Hunter Transmission Project (SSI-70610456) Submission

We refer to the critical State significant infrastructure application (SSI-70610456), environmental impact statement (**EIS**) and accompanying documents for the proposed Hunter Transmission Project (HTP), placed on public exhibition on 27 August until 24 September 2025.

Annexure A – HVO Submission

Annexure B – Alignment Examples

Figure 1: Hunter Transmission Project - Northern Dam Tracks

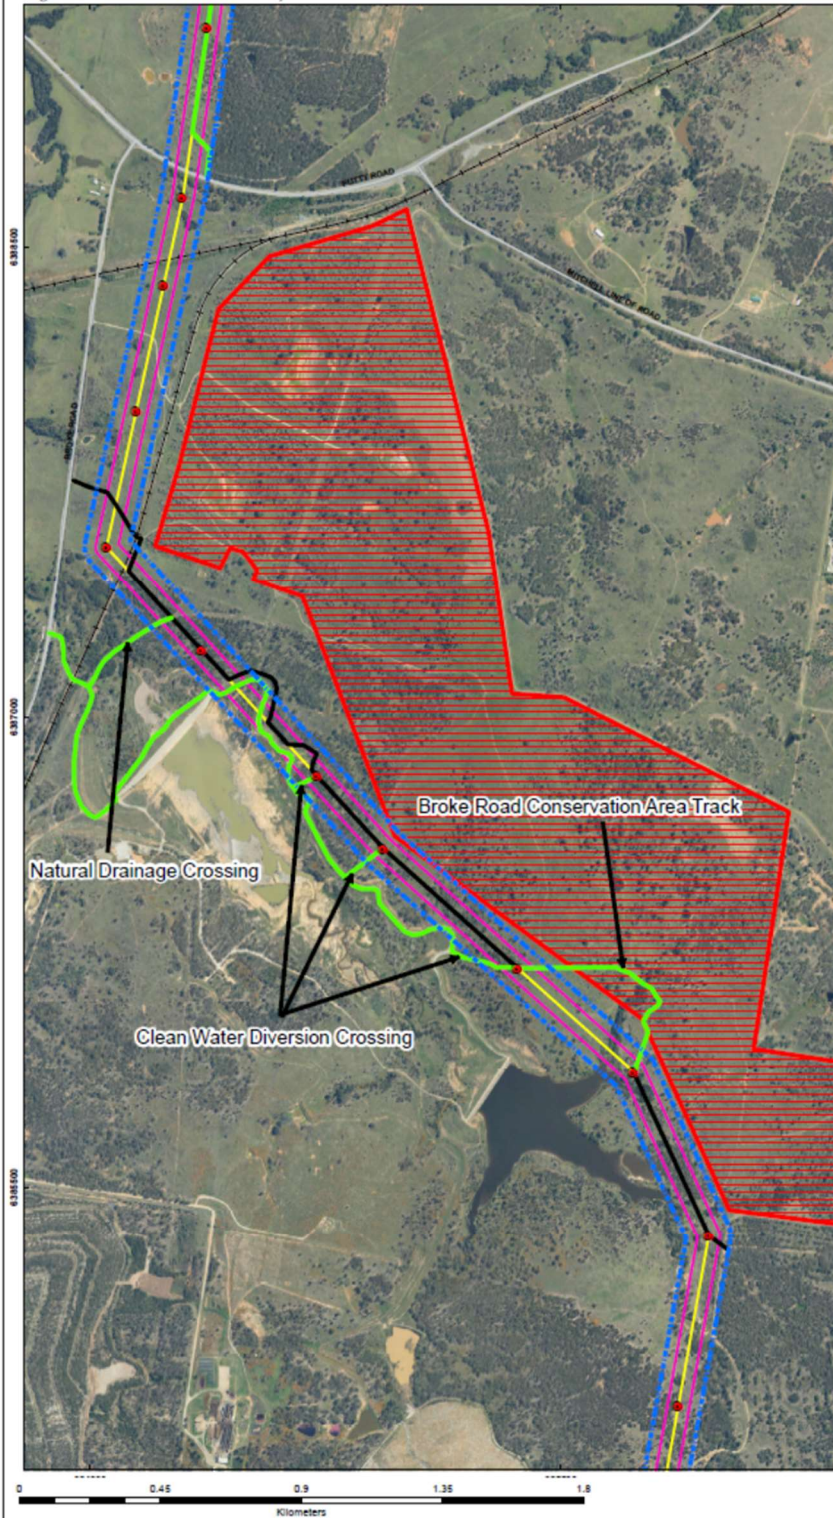
The construction and operational access routes proposed in the EIS, Technical Report 4 Map 2 are inappropriate. The HTP's proposed access crosses the natural drainage below the Bulga Coal Northern Dam, three times across the northern clean water diversion drain and into the Broke Road Biodiversity Offset property, as shown in **Annexure B Figure 1** and associated photos.

Natural Drainage Line crossing

Clean water diversion crossing locations, diversions are 2 to 3m deep and travel up a steep slope.

Eastern clean water diversion, 3 to 4m deep and travels up a steep slope.

Bulga Coal proposed an access route that has substantially less impact (see **Figure 1**) as it utilises the area that will be cleared under the transmission lines and would:

- avoid all water courses
- avoid steep slopes
- avoid the Broke Road Biodiversity Offset property and;
- maintain HTP separation from Bulga Coal's operational tracks and activities.
